**DONALD W. MCINTOSH
ASSOCIATES, INC.**

MEMORANDUM

RE: Comments on the March 2010
Draft Stormwater Quality Applicant's Handbook

Phosphorus Trends in Florida Waters 1970 - 2005

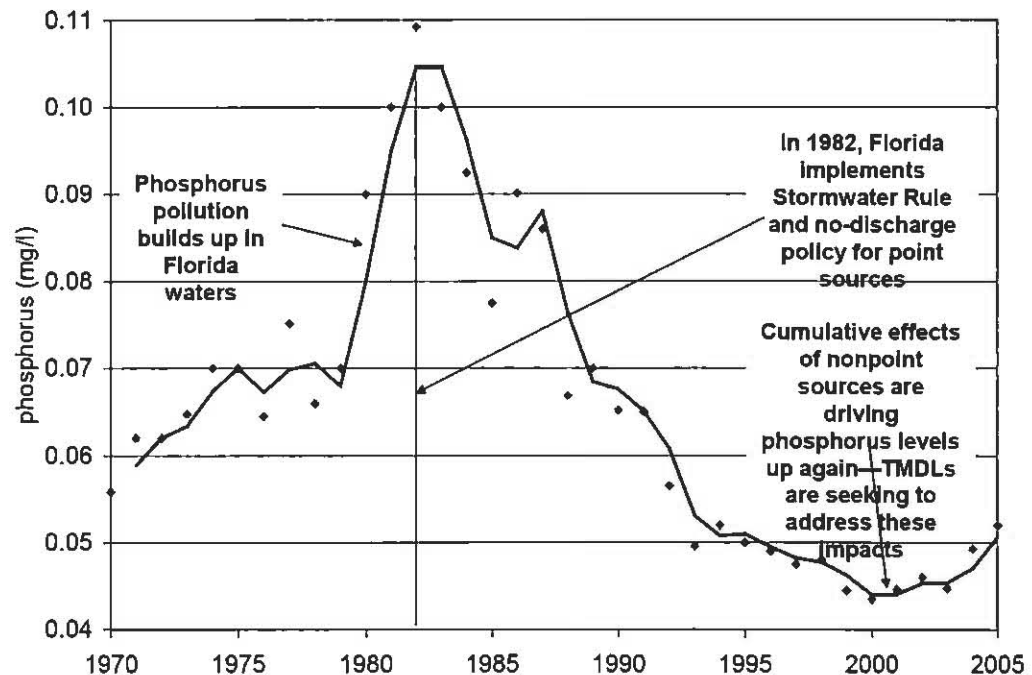
1. As evidenced by the chart below that was included in the presentation provided by the FDEP at the May 19, 2010 public workshop in Orlando, Florida, the stormwater management practices that have been employed since 1982 have resulted in significant reductions of phosphorous levels, dramatically reversing the trend prior to 1982, even as development has increased considerably during the same period. While it is acknowledged that nutrient management is still a concern and more may need to be done, it would appear that only slight modifications are needed to the existing methods of stormwater quality management to increase the effectiveness and possibly achieve the desired levels of nutrient management. The methodologies and requirements provided in the March 2010 Draft Stormwater Quality Applicant's Handbook represent a sea change in the management of stormwater quality within the State of Florida. Unfortunately, the Draft Handbook has the potential for also causing a sea change in the costs and complexity associated with design, construction, land, operation, maintenance and compliance for stormwater management systems in the State of Florida. Steep increases in costs that will provide only minor increases in nutrient reduction over current treatment criteria will result in wasted economic resources.
